Re: Response to Technical Revision (TR-05) Preliminary Adequacy Review; Permit No. M-1977-559, Canon City East Pit

SPECIAL REVIEW USE PERMIT
PRIVATE RECREATION USE
SOUTH FORTY RECREATION, LLC
 FREMONT COUNTY, COLORADO

EXHIBIT
SRUP-46.1
 1766001

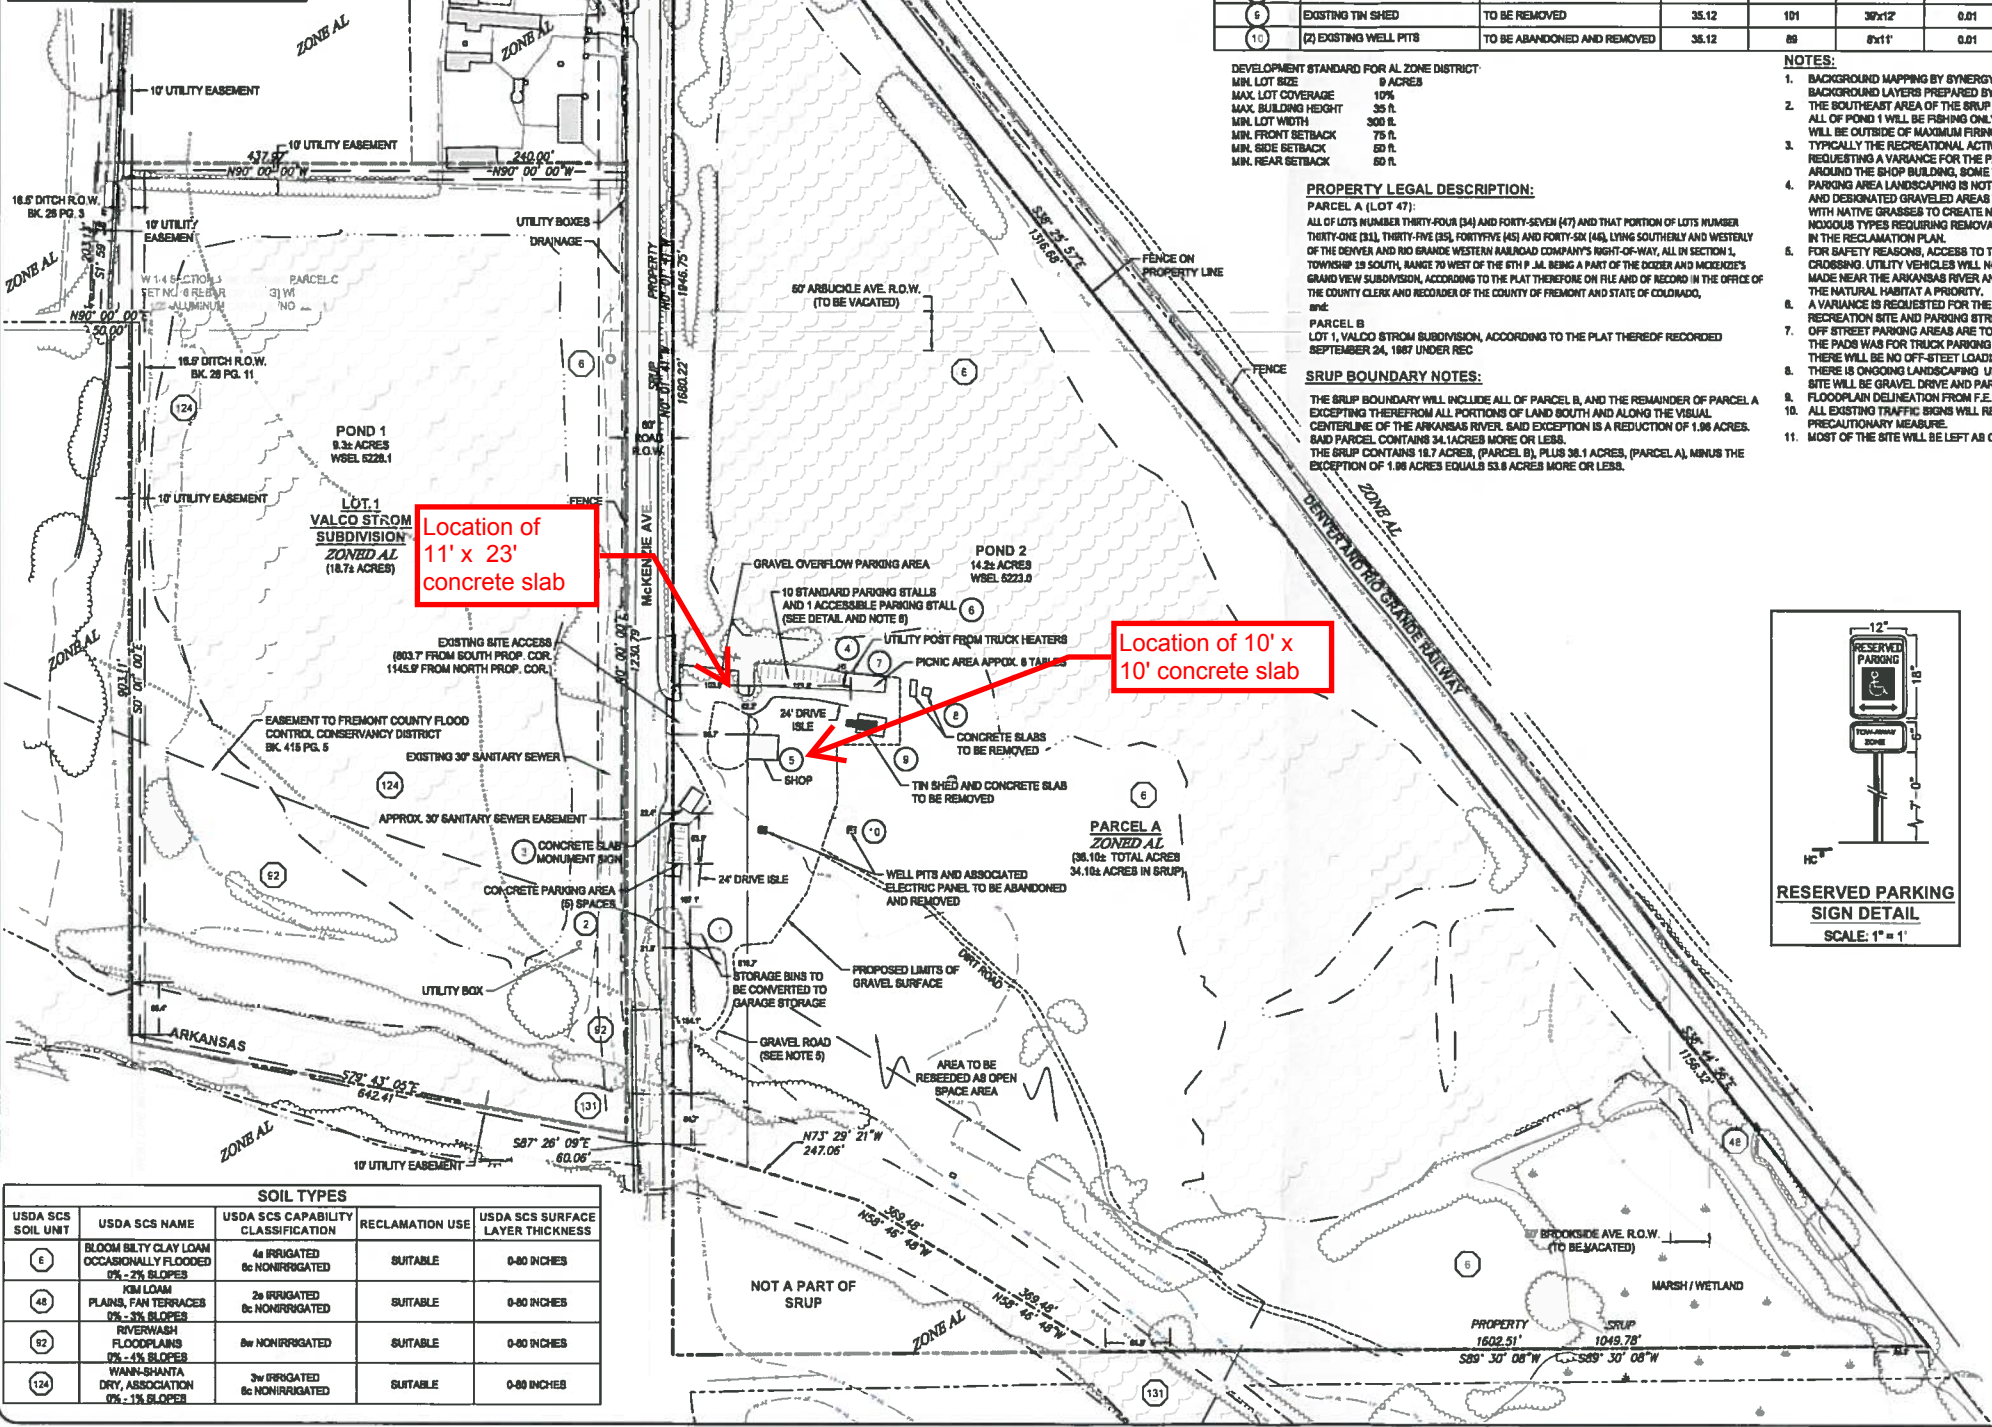
The following clarification is required. Attachment #1 lists four concrete pavement areas to remain. The Division could not match the dimensions of these four concrete pads with those listed in the Structure Table on Exhibit SRUP-46.1. To assist the Division in understanding which concrete paved areas are to remain, please provide the Structure Map Sym. and clarification on the dimensions for each of the following:

- *Concrete pavement/parking area, north of shop (approximately 25' x 180')*
- *Concrete pavement/parking area, east of shop (approximately 25' x 40')*
- *Concrete pavement/parking area, north of bunkers (approximately 30' x 60')*
- *Concrete slab by original gate (landscape parking antique dump truck)*

The Structure Map Symbols that correspond to each of these four concrete pavement areas are provided in the following table. The descriptions provided below for each of these areas match those given in the TR-05 Request. However, the dimensions previously provided for these areas were approximations (as noted in the TR-05 Request); the dimensions provided in the following table are consistent with Exhibit SRUP-46.1.

Pavement Area Description	Structure Map Symbol	Dimensions
Concrete parking/paving area, north of the shop	6	111' x 25'
Concrete parking/paving area, east of the shop	7	57' x 22'
Concrete pavement/parking area, north of bunkers	2	50' x 28'
Concrete slab by original gate (landscape parking antique dump truck)	3	15' x 30'

EXHIBIT A

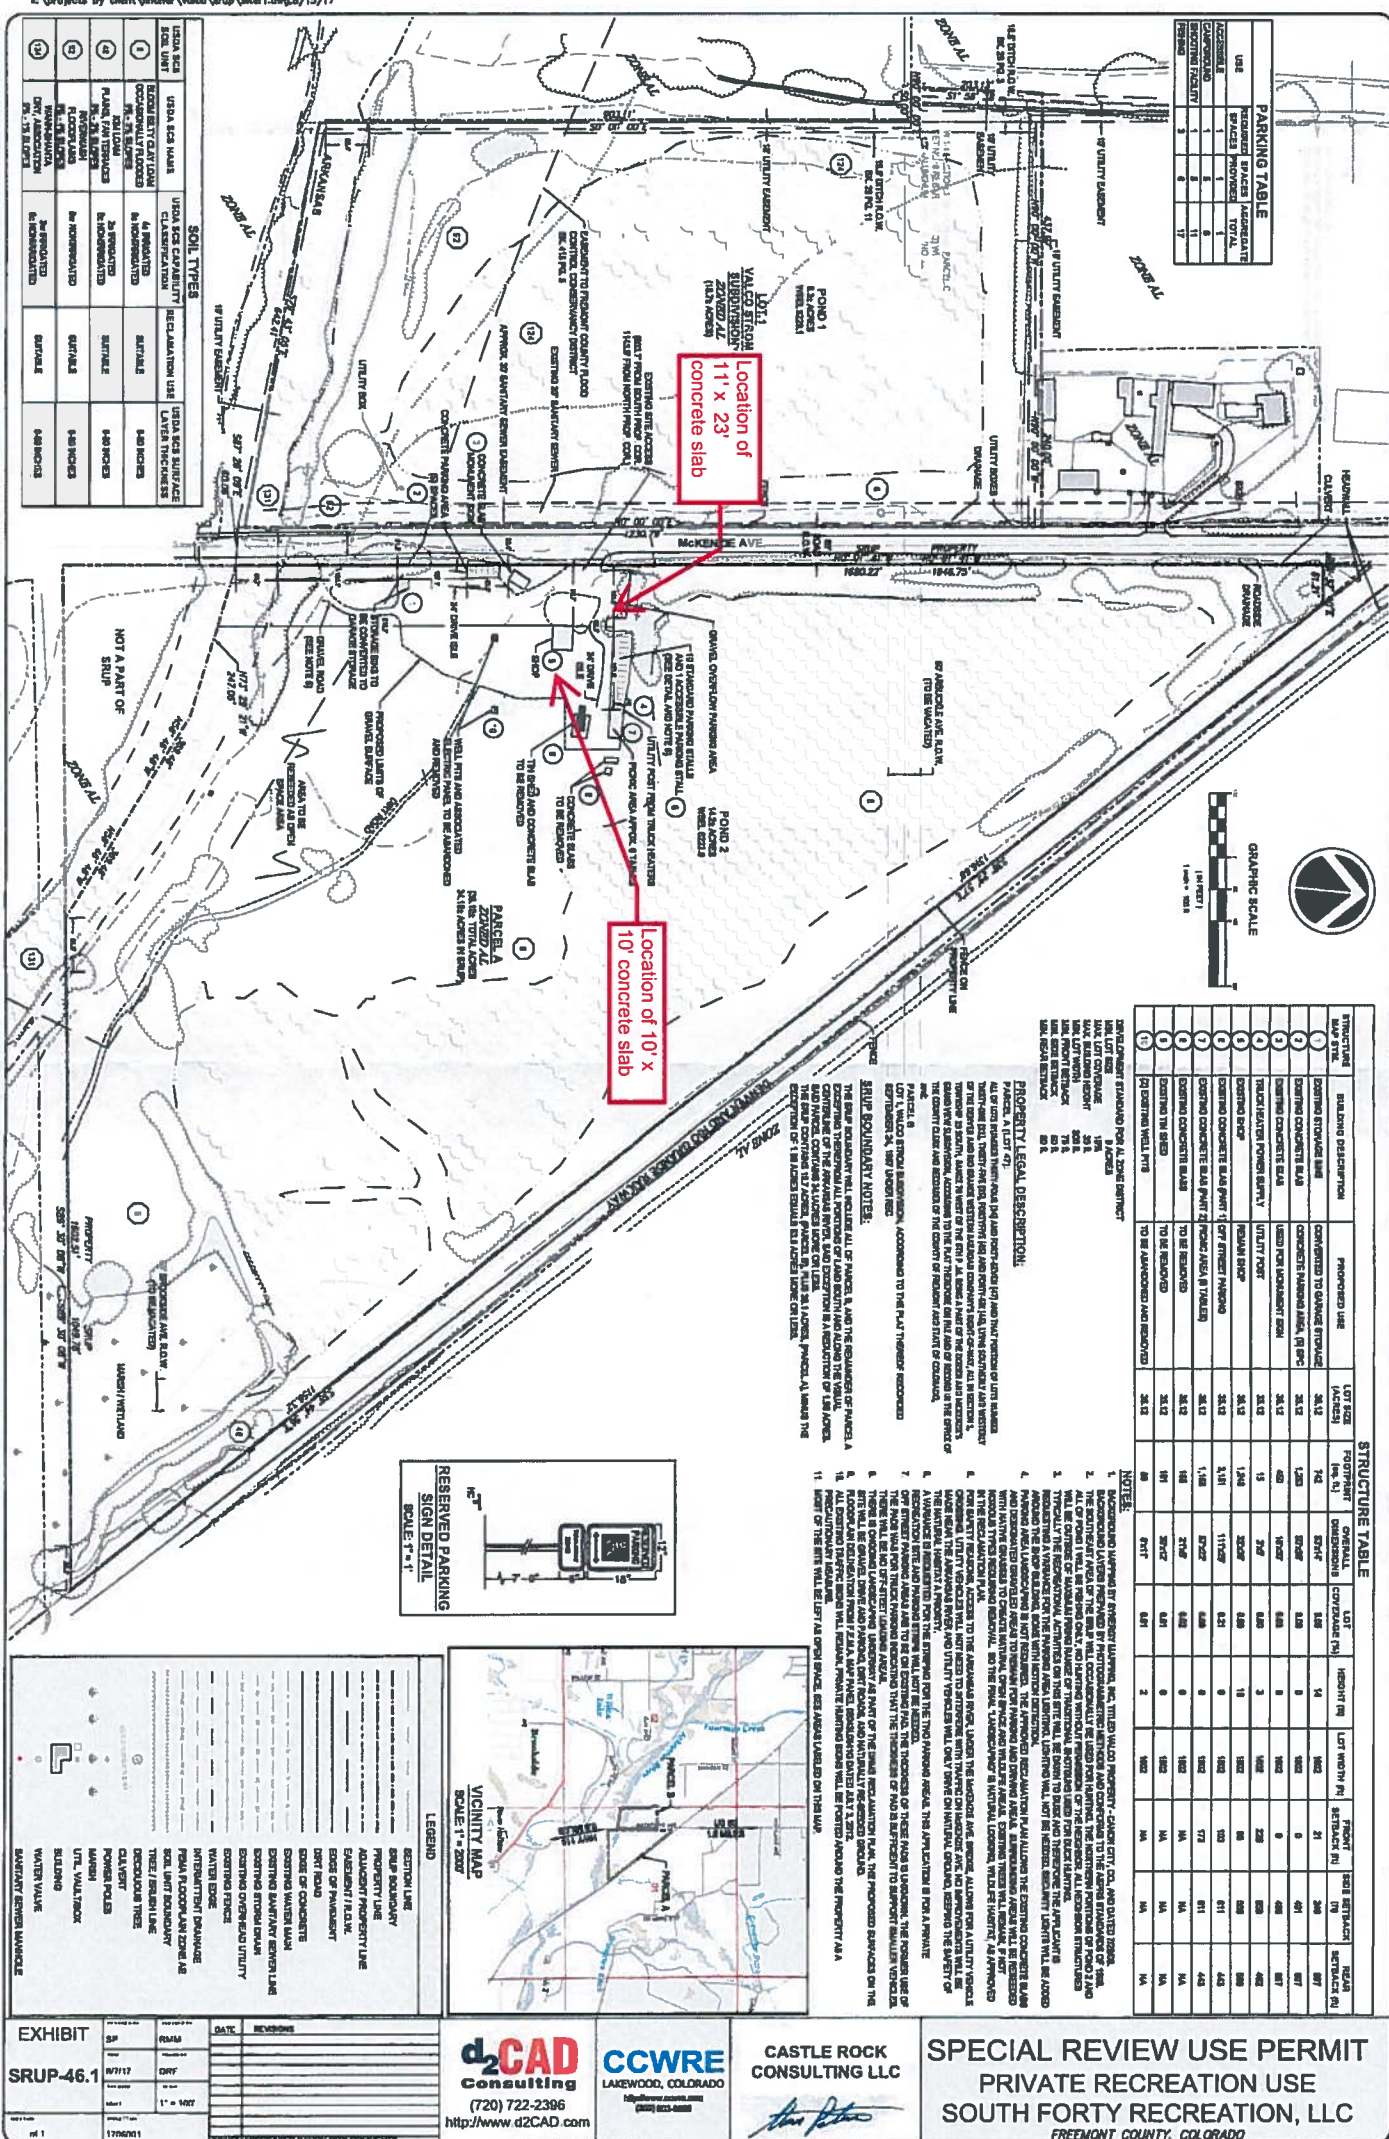
Additionally, please note that there are two additional existing concrete pavement areas on the property, which do not appear on Exhibit SRUP-46.1 but are in the locations indicated on Exhibit A. Photographs of the existing slabs, which measure approximately 10' x 10' and 11' x 23', are attached as Exhibit B. A letter to the Fremont County Department of Planning and Zoning and associated letter in response, confirming that these pavement areas are considered incidental to the use of the property and are permitted to remain under the Special Review Use Permit granted by the Fremont County Board of County Commissioners on October 24, 2017, are attached as Exhibit C.

Upon review of the information provided, the existing concrete slabs remaining on the property at 730 South Mackenzie Ave., in Canon City and approved by Special Review Use Permit 17-005 have no impact on the approval and may remain on the property.

EXHIBIT B

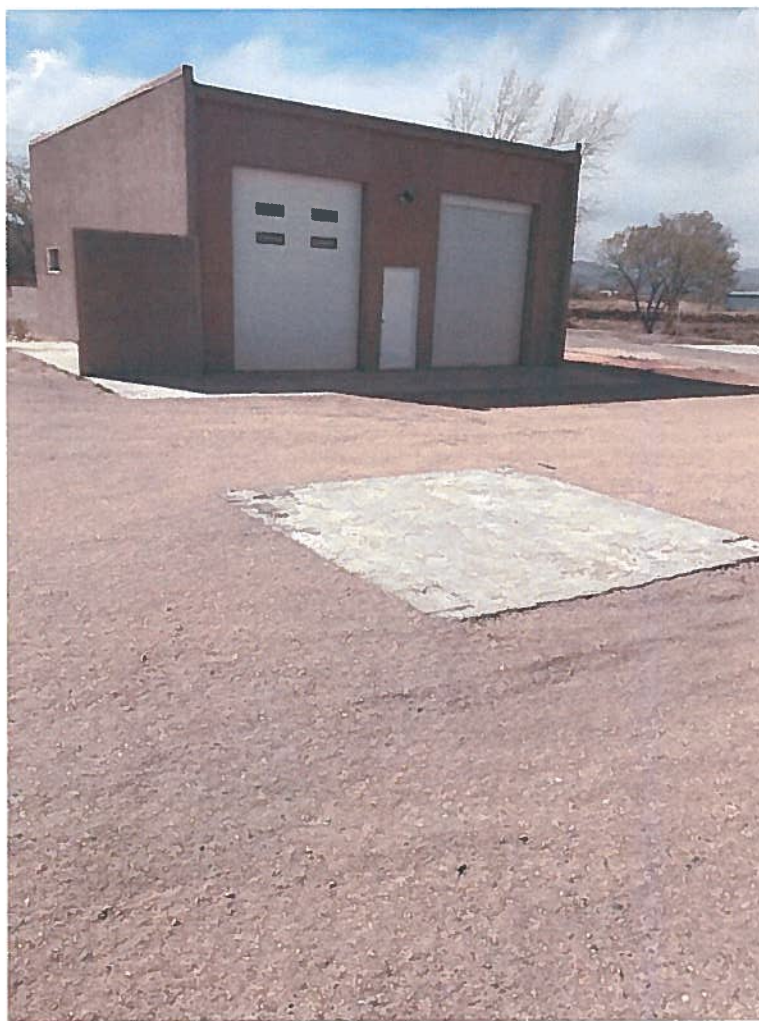
Concrete slab measuring approximately 10' x 10' located to the east of the shop building.
